**BEFORE THE MONTGOMERY COUNTY
BOARD OF APPEALS**

**IN THE MATTER OF:
PETITION OF LITTLE FALLS
SWIM AND TENNIS CLUB**

Board of Appeals Case No. S-289-B
(OZAH Referral No. 04-43)

FOURTH SUPPLEMENTAL HEARING EXAMINER'S REPORT AND RECOMMENDATION

Lighting Plan/Photometric Plan, Ex. 228(a)

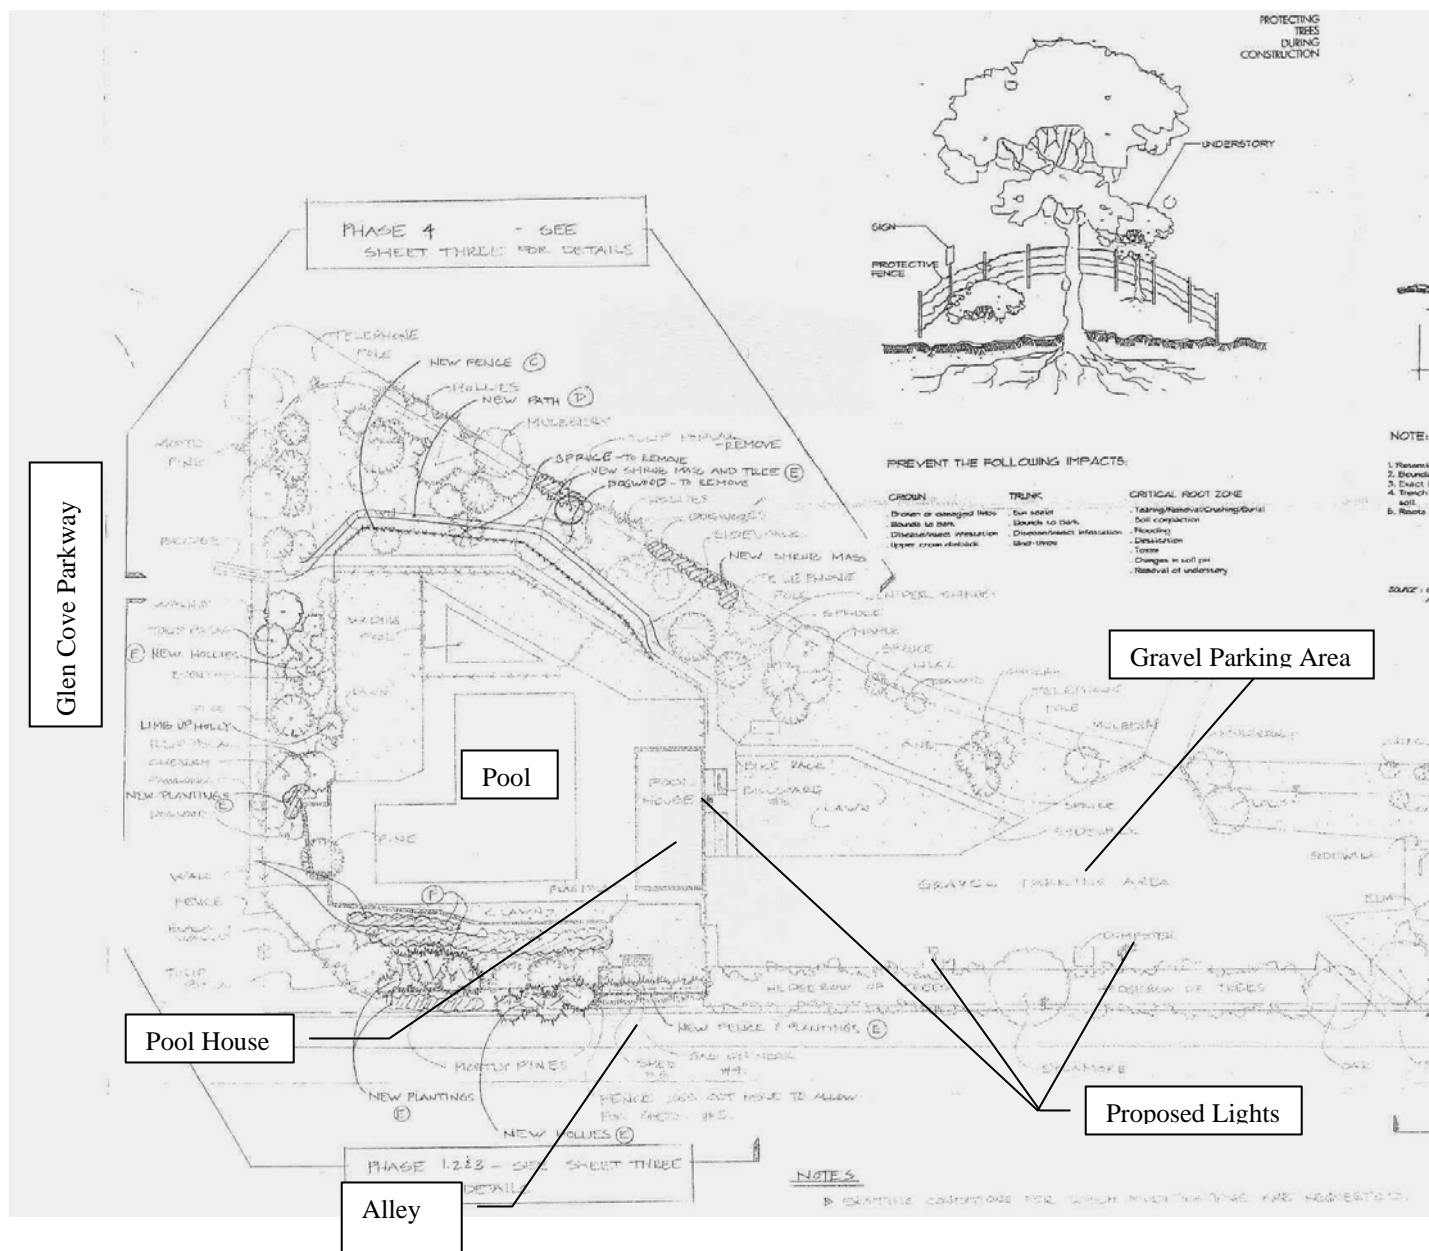
The proposed Lighting Plan, Exhibit 228(a) (which is labeled "photometric plan," but serves as a lighting plan as well), calls for two pole lights in the parking lot, each with a total height of 15 feet, including the base, plus one light fixture mounted on a bracket at the apex of the front of the pool house. All three fixtures would use 150-watt lights, tilted and with cut-off features to direct the illumination into the parking lot and away from the property lines. Based on the specifications submitted for the light fixtures and a quote from an electrician, the lights would be the same on all three fixtures, except for their method of mounting (wall-mounted v. pole-mounted). The relevant portion of the Lighting Plan/Photometric is reproduced on the next page, followed by the relevant portion of Page

The Lighting Plan/Photometric Plan indicates that the maximum level of illumination along the rear property line, abutting the alley, would be 0.02 foot-candles. This represents a very low level of illumination, well below the maximum of 0.1 foot-candles established in the Zoning Ordinance as permissible along a rear property line for a special exception in a residential zone. See Code § 59-G-1.23(h). At a height of 15 feet, the proposed pole lights would be much less obtrusive than the existing 30-foot poles. The fixture proposed for the pool house would be mounted at a height of 18 feet, which is also much less obtrusive than the current poles. Moreover, the pool house fixture would be a greater distance from the alley property line than the pole fixtures, resulting in no illumination from

the pool house fixture at the property line. Moreover, the pool house fixture would shed no light towards Glen Cove Parkway, because the building itself would block light in that direction.

Based on the Swim Club's written submissions, Technical Staff's favorable review, and the total absence of comments from the community – in a community that has been very forthcoming with comments in earlier stages of this case – the Hearing Examiner concludes that the proposed Lighting Plan would have no adverse effects on the immediate neighbors or the general neighborhood, and should be approved. Specifically, the Hearing Examiner recommends approval of Exhibit 228(a), which is a full-size survey of the subject property with handwritten depictions of the proposed light fixture locations and photometrics. It is labeled "Survey of Mark Property on Both Sides of Public Alley" in the bottom right corner, and is labeled "Photometric Plan," by hand, in the lower left corner. The Hearing Examiner further recommends that if Exhibit 228(a) is approved as a Lighting Plan, the Swim Club should be required to submit for the Board's approval a final Landscape Plan that depicts the light fixtures shown on Exhibit 228(a). Should the Board wish the Hearing Examiner to review the final Landscape Plan prior to its consideration by the Board, I will be happy to do so.

1. Approve Exhibit 228(a) as the final Lighting Plan, and require that the Swim Club either affix a label to that plan re-naming it "Lighting Plan," or submit a new copy of the plan with "Lighting Plan" as its title.
2. Direct the Little Falls Swim Club to submit for approval a revised Landscape Plan, with all three sheets, as required by the Board's Resolution in this matter effective May 3, 2006, showing the locations of the lighting fixtures depicted on Exhibit 228(a).
